LEITNER-POMA SERVICE NOTICE

NOTICE NO: SN-0701-01-R0

AFFECTED COMPONENTS: BM Manufactured Chairs

SUBJECT: Armrest Bracket Holes

**ARMREST BRACKET
(ASSEMBLED)**

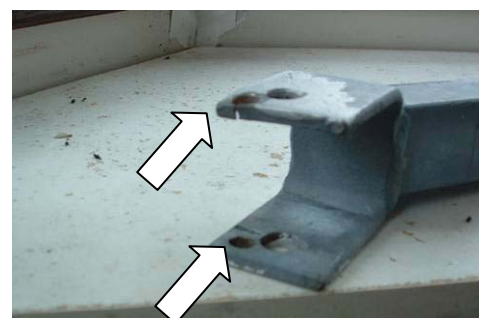
It has been very recently discovered that some BM supplied chairs have had additional hole(s) drilled in the armrest attachment brackets in an apparent attempt to resolve initial assembly fit-up problems. Also, some of the holes (original or additional) have been found to be drilled too close to the edge of the material. For this particular type of application, the distance from the edge of a hole to the edge of the material should not be less than 2 X the material thickness.

1. **CONDUCT 100% VISUAL INSPECTION OF ALL CHAIRS:** This step should be taken to ensure that all potential trouble areas are identified. Please refer to the photos below for guidance.

2. **REPORT ANY OCCURENCES:** If any extra holes are found, or if a holes edge is found to be closer than 2 X the material thickness from the material edge, please contact Leitner-Poma Canada by fax and provide a summary report indicating the installation number of the lift and the quantity of carriers that have been affected. A repair procedure is being developed and will be distributed accordingly.
3. **CONFIRM THE RECEIPT OF THIS NOTICE:** (mandatory) Please complete, sign, and fax back the following page as acknowledgement of receipt to:

**EXAMPLE OF ADDITIONAL HOLE(S)
(ISO VIEW)**

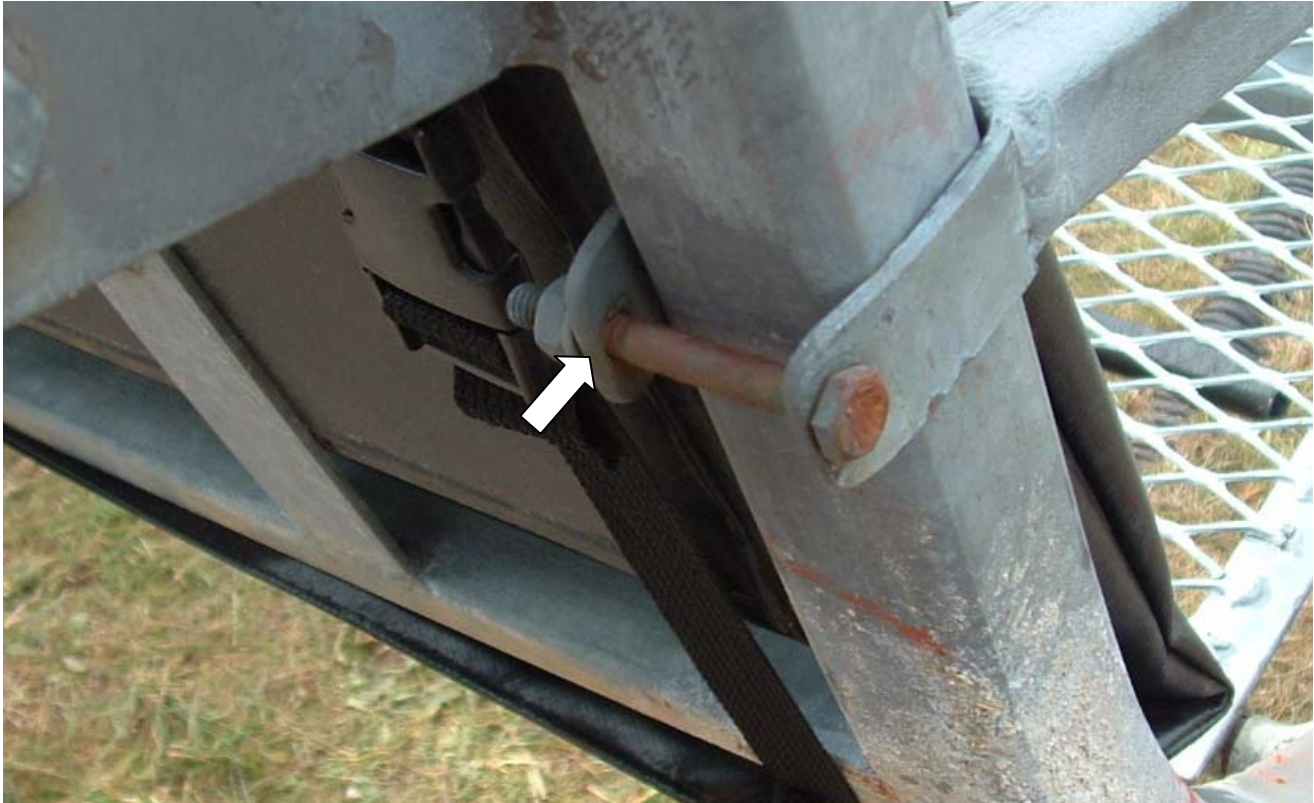
EXAMPLE OF HOLE TOO CLOSE TO EDGE
